01 Floor plans

Level 08 Floor Plan

Consented Design - GA Level 08

Proposed Design - GA Level 08

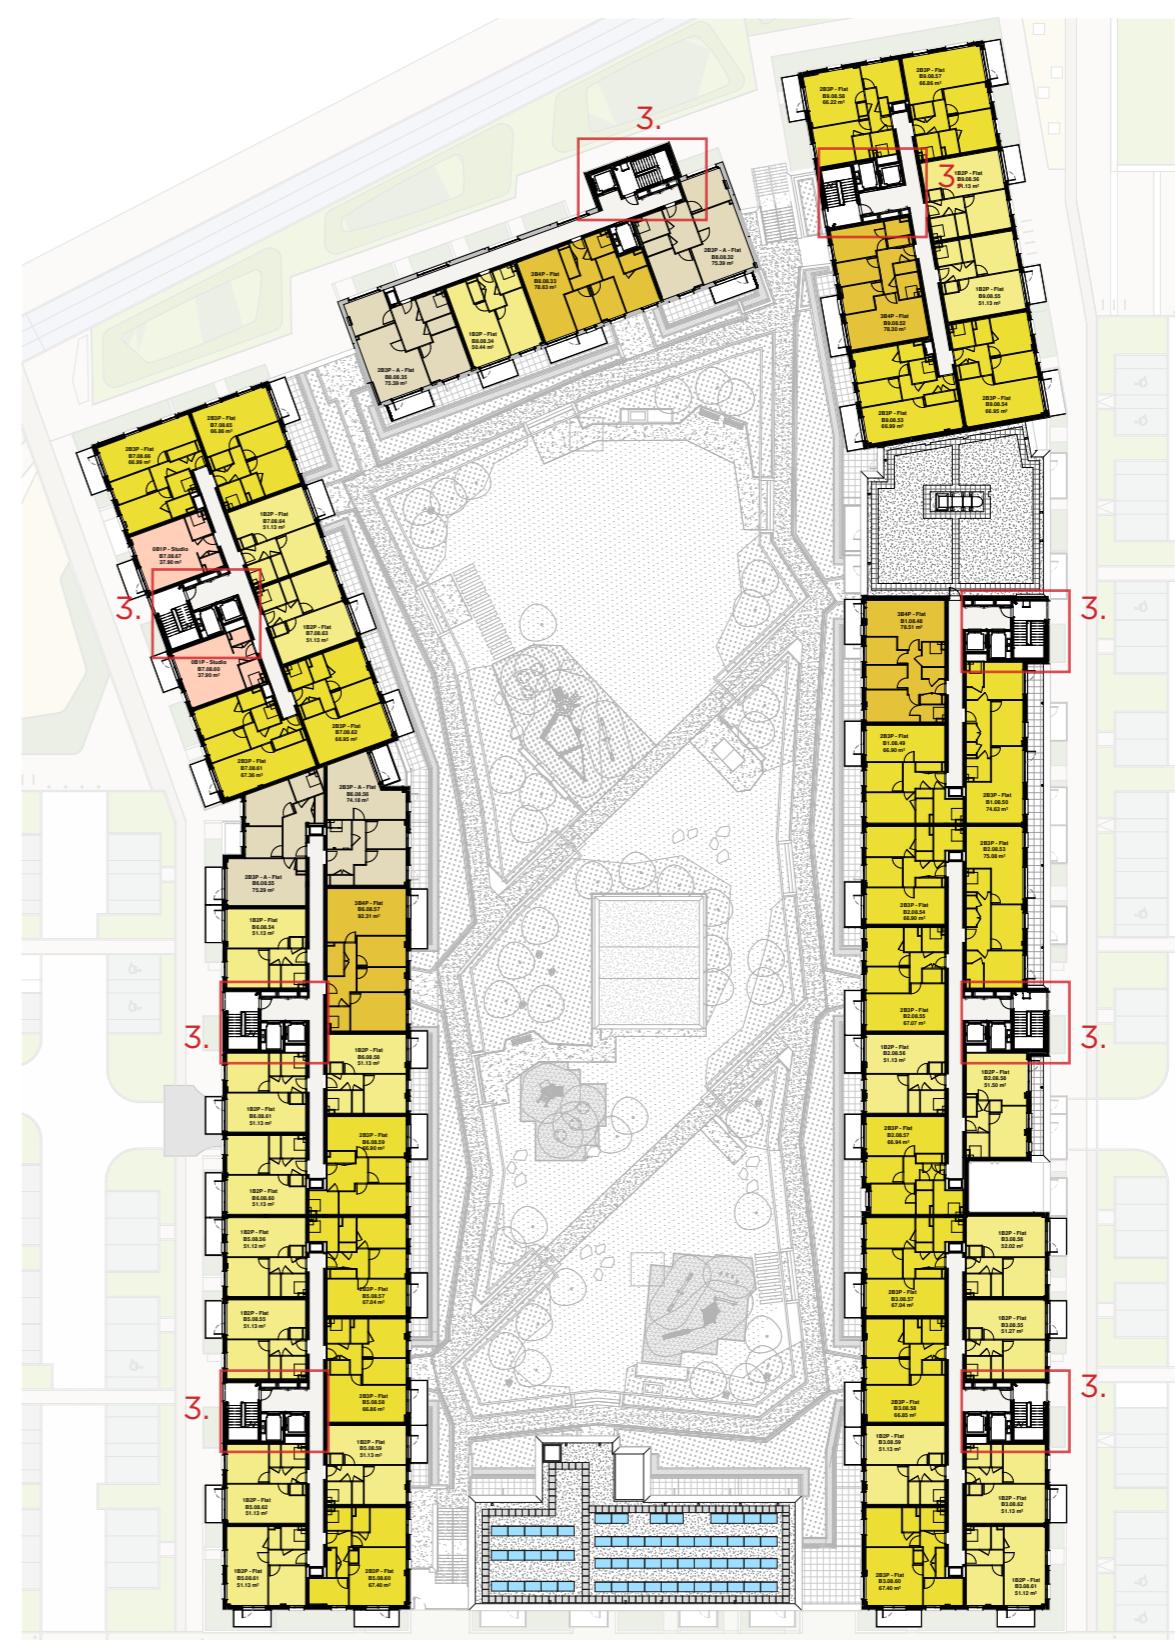
1. Omission of podium entrance canopies; security risk to adjacent apartments at first floor.
2. Addition of plant housing for car park smoke extract fans as per developed fire strategy
3. Updated core layout as per developed fire strategy; evacuation lifts added to Blocks 4 and 8
4. Reconfiguration of apartment layout. Overall mix remains as consented.
